# Access Compliance Report

## Public Rights-of-Way

Intersection ID: 23386	Main Street: ALEXANDER_RD	Cross Street: BENNING_WOOD_DR	Location: NE
ADA ID: 537525F20FFB	Ramp Type: Directional1	Initial Pass/Fail: Fail	Overall Compliance: No
Severity Score: 1.25			
Codes/Mitigation Info/Possible Solution		Field Measurements/Component Compliance

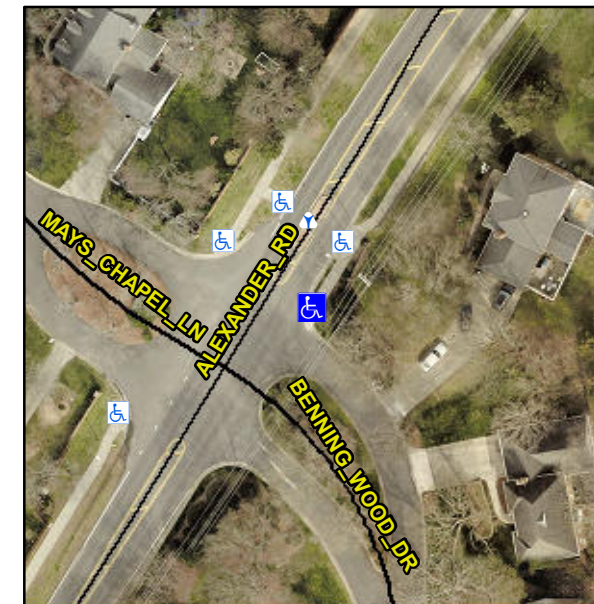
Compliance	Description	Data	Compliance	Description	Data
N/A	Ramp Length (in)	85.0	N/A	Grade Break?	N/A
Yes	Ramp Width (in)	70.5	N/A	Grade Break Slope (%)	0.0
Yes	Ramp Slope (%)	7.7	N/A	Grade Break XSlope (%)	0.0
No	Ramp XSlope (%)	2.1			
N/A	Flare Type LT	N/A	N/A	Flare Type RT	N/A
N/A	Flare Slope LT (%)	N/A	N/A	Flare Slope RT (%)	0.0
N/A	Flare Traversable LT?	N/A	N/A	Flare Traversable RT?	N/A
N/A	Landing Length (in)	0.0	N/A	DWS Provided?	N/A
N/A	Landing Width (in)	0.0	N/A	DWS Contrast?	N/A
N/A	Landing Slope (%)	0.0	N/A	DWS Length (in)	N/A
N/A	Landing X Slope (%)	0.0	N/A	DWS Full Width?	N/A
N/A	Landing Curb? (Y/N)	N/A	N/A	DWS Offset LT (in)	N/A
N/A	Shared Landing?	N/A	N/A	DWS Offset RT (in)	N/A
N/A	Gutter Ponding?	0.0	N/A	Gutter Slope (%)	N/A
N/A	Gutter Lip Ht (in)	0.0	N/A	Gutter X Slope (%)	N/A
N/A	Painted X Walk1?	No		Road Slope (%)	0.1
	X Walk 1 Direction	To SW		Road X Slope (%)	6.5
	X Walk 1 Width (in)	N/A		Clear Space?	N/A

X Walk 1 Slope (%)	0.1	N/A	Clear Space to XWalk (in)	N/A
	X Walk 1 X Slope (%)	6.5	N/A	Storm Grate/Utility Hazard?	N/A
N/A	Ramp inside XWalk1?	N/A		Storm Grate/Utility Type	
N/A	Any Obstructions?	N/A			N/A
	Obstruction Type		Yes	Surface Condition? (G/P)	Good
			N/A	Curb Slope (%)	7.7

**Remove & Replace Entire Ramp.**

**R304.5.3**
